Johns Creek

Board of Zoning Appeals Meeting November 17, 2020

CASE NUMBER:	V-20-005
PROPERTY LOCATION:	520 Harbour Gate Circle, Johns Creek, GA 30022
CURRENT ZONING:	R-4A (Single-Family Dwelling District) Conditional
PARCEL SIZE:	0.66 Acres
PROPERTY OWNERS:	Richard and Jill Levine
VARIANCE REQUEST:	20-foot encroachment into the 75-foot stream buffer to construct a pool, patio and retaining wall
STAFF RECOMMENDATION:	APPROVAL WITH CONDITIONS

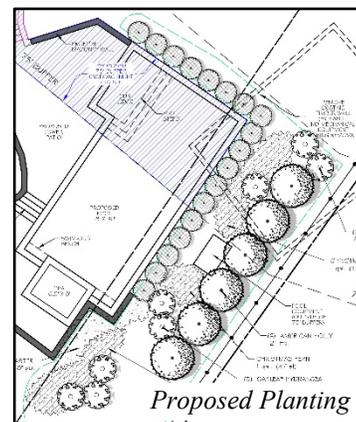
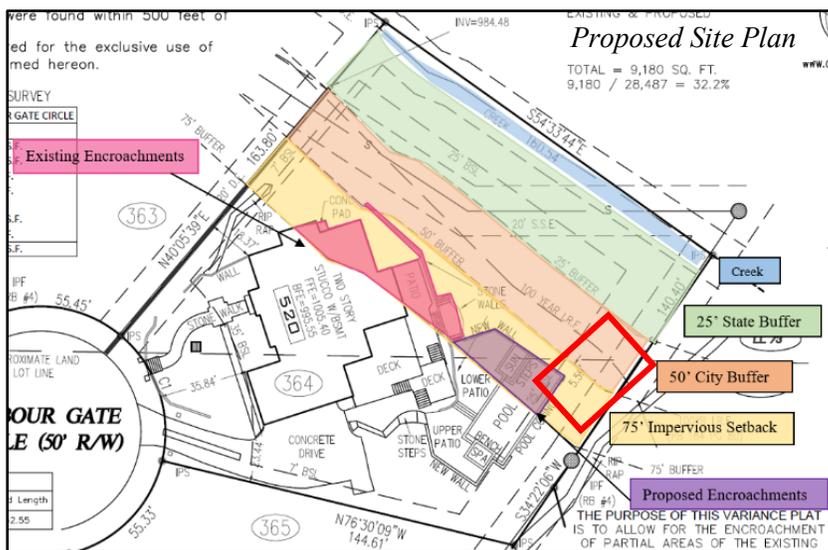
The Applicant is requesting a stream buffer variance to allow a portion of a pool, patio and retaining wall to encroach 20 feet into the 75-foot impervious surface setback portion of the stream buffer. The proposed addition is approximately 1,988 square feet, but only 710 square feet (highlighted in light purple) is located within the 75-foot impervious surface setback. The Applicant has not proposed any land disturbance or impervious surface within the 50-foot undisturbed stream buffer.

It should be noted that a portion of the existing house and patio (highlighted in red) are located within the 75-foot impervious surface setback as well. There is an existing playground structure in the rear yard, enclosed by a 10-inch tall timber wall (outlined in red), and the Applicant has proposed to remove both the playground and timber wall using non-motorized equipment as additional mitigation for the proposed encroachment.

The subject property was platted in Fulton County in 1994 with a 25-foot undisturbed stream buffer in the rear. However, after the incorporation of the City in 2006, the stream buffer was expanded to 50 feet and the additional 25-foot impervious surface setback was added. The expansion of the stream buffer creates a hardship for the homeowner and requires them to submit for a variance, as even portions of the existing home and patio are located within the 75-foot impervious surface setback, which would not be permitted today without a stream buffer variance.

In order to mitigate the impact of encroachment into the stream buffer, the Applicant has proposed to install a dry well to capture the first 1.2 inches of runoff for the 710 square-foot encroachment, along with vegetative planting to infiltrate, and further reduce and slow stormwater runoff associated with the proposed expansion of additional impervious surface on the property.

- 1) The encroachment of the proposed development shall not exceed 20 feet in depth and 710 square feet of impervious surface into the 75-foot impervious surface setback, as shown on the site plan received by the Community Development Department on October 21, 2020.

- 2) No land disturbance shall occur within the 50-foot City stream buffer or the 25-foot State stream buffer.
- 3) The Applicant is required, prior to the issuance of a building permit, to receive approval from the City's Land Development Manager for a stream buffer mitigation plan to offset any adverse impacts associated with the additional impervious surface. Said plan shall be consistent with the mitigation plan proposal received by the Community Development Department on October 21, 2020. The mitigation plan shall be submitted, approved, and inspected, prior to the issuance of a Certificate of Completion.

- 4) The Applicant is required to remove the existing playground structure and timber wall using non-motorized equipment, prior to the issuance of a building permit.
